Consultant Advice

From: Renzo Arango **Date:** 18 Feb. 15 **File No:** S30229\001\W-121\ca150217s0019 **Pages:** 3
Project: Hornsby Ku-Ring-Gai Chase Hospital - Acoustics Consultancy Services **No:** J-030[1.0]

Acoustics – Assessment of Stand-by Generator

Figure 1: Recommended barrier layout (not to scale)

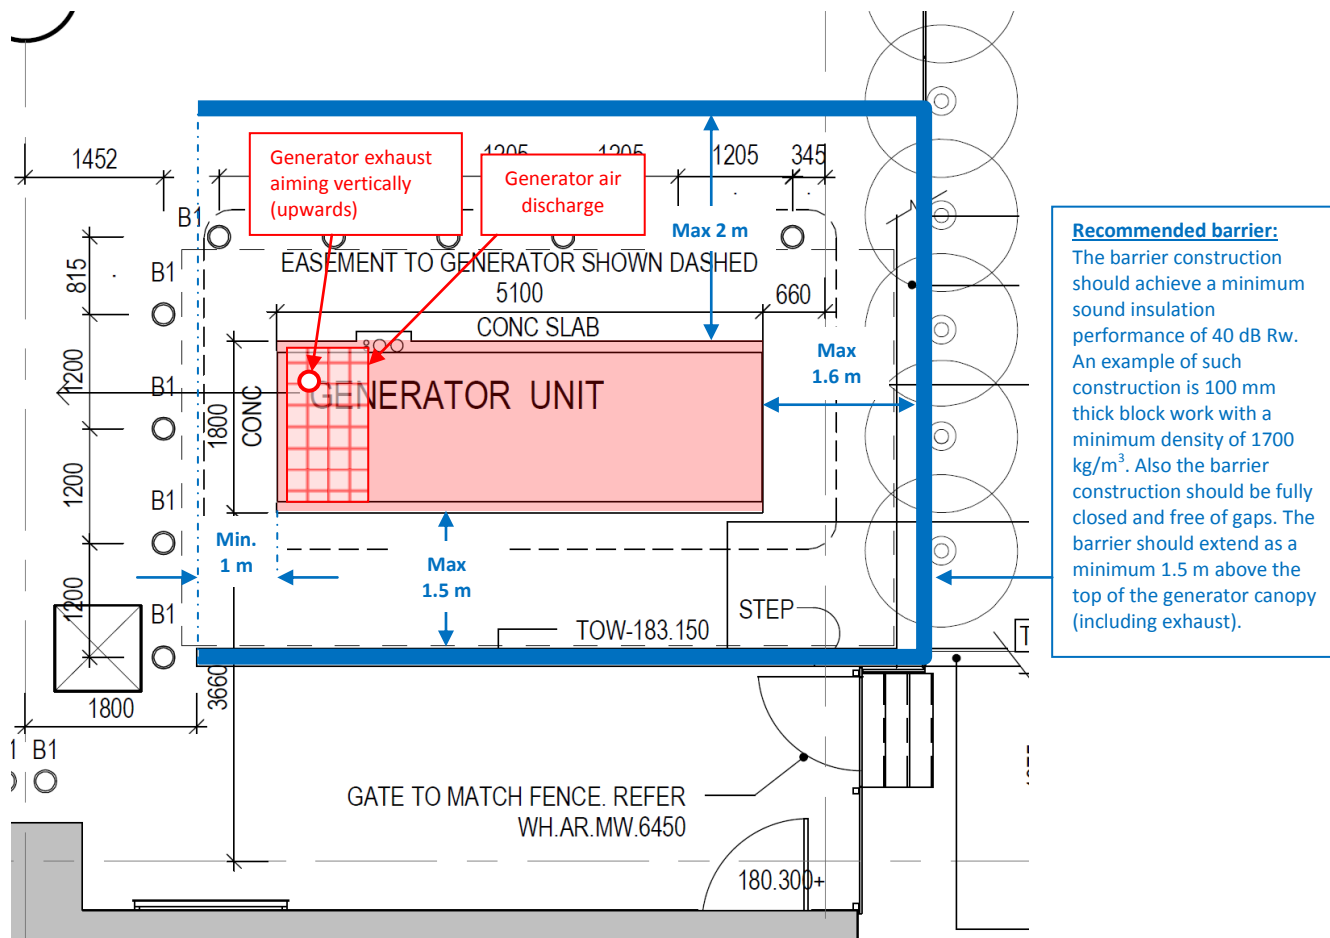
- The location, extent and height of the noise barrier shown in Figure 1 is acceptable to meet the compliance condition for maintenance operation only. This is on the basis that the barrier treatment is as per recommendations discussed in NDY correspondence J-028 ca150202s0021 and the operation of the plant for maintenance is as per Section 8 of the NDY Detailed Design Acoustic Report (refer also to Aconex Correspondence RCC-GCOR-004628, dated 29th January 2015).
- The barrier construction should achieve a minimum sound insulation performance of 40 dB R_w as outlined in CAN J-028.

- It is recommended that the generator should be oriented in such a manner that the exhaust and air discharge are aimed away from Burdett Street (refer to Figure 1). It is also advised that based on the height of the noise barriers noted above, that the exhaust should be aimed vertically (i.e. upwards).
